Contract #: 04-0120F4
 Cty: SF/ALA Rte: 80 PM: 13.2/13.9
 File #: 69.25B

QUALITY ASSURANCE -- NON-CONFORMANCE REPORT

Reference Description: Excessive Heat Utilized during Heat Straightening of CB18 Floorbeam FB3168A

Job Name: SAS Superstructure
Document No: 05.03.06-000796

Reference Description: Excessive Heat Utilized during Heat Straightening of CB18 Floorbeam FB3168A

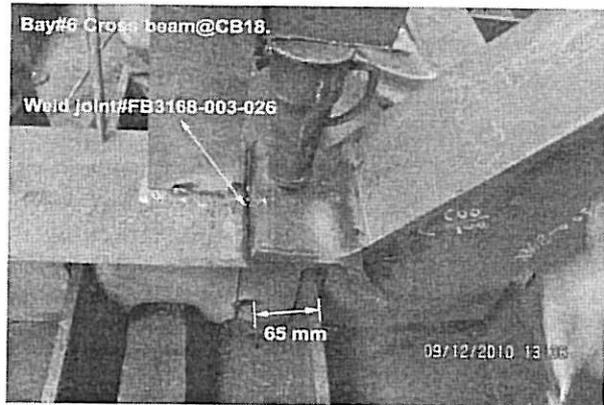
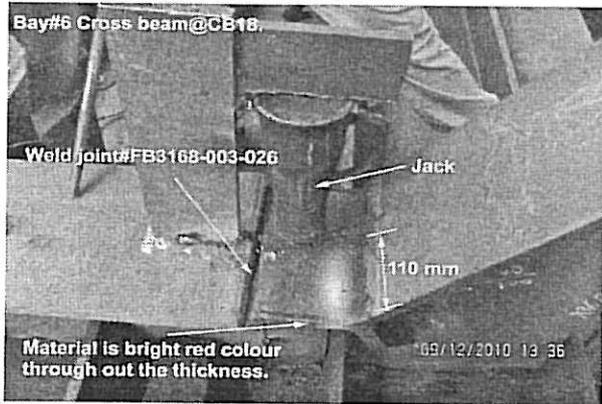
During the Quality Assurance random in-process observations of the fabrication of OBG Crossbeam CB18, Quality Assurance observed the following:

- During the fit up of the Floorbeam Diaphragms on CB18, ZPMC personnel appear to have overheated the flange base metal. The material was heated to a bright red/yellow condition.
- AWS D1.5 2002 defines the color of material heated to 650C as a "dull red color".
- The corner diaphragm flange is identified as X3735A.
- The weld joint number nearest to the heated area is identified as FB3168-003-026.
- The area being heated is approximately 65 mm from the above mentioned weld joint.
- The length of the heated area is approximately 110 mm parallel to the above mentioned weld joint.
- CB18 is located in sub assembly Bay # 6.

AWS 1.5 2002 section 3.7.3 "Members distorted by welding shall be straightened by mechanical means or by carefully supervised application of a limited amount of localized heat as approved by the Engineer. The temperature of the heated areas as measured by approved methods shall not exceed 600°C [1100°F] for quenched and tempered steel nor 650°C [1200°F] (a dull, red color) for other steels. The part to be heated for straightening shall be substantially free of stress and from external forces, except those stresses resulting from the mechanical straightening method used in conjunction with the application of heat."

Contractor will perform hardness test on the heated area, and submit the results to the Department for review. NDT will be performed on the adjacent welds to show the welds are not adversely affected by the heating. Contractor will in pose fine on the work crew perform overheating.

Contractor performed the hardness testing of the heated area and the adjacent area affected by overheating to show that the heating did not adversely affect the material. NDT was performed, and material result is acceptable. Contractor has issued notification to fine the work crew who performed the heating.
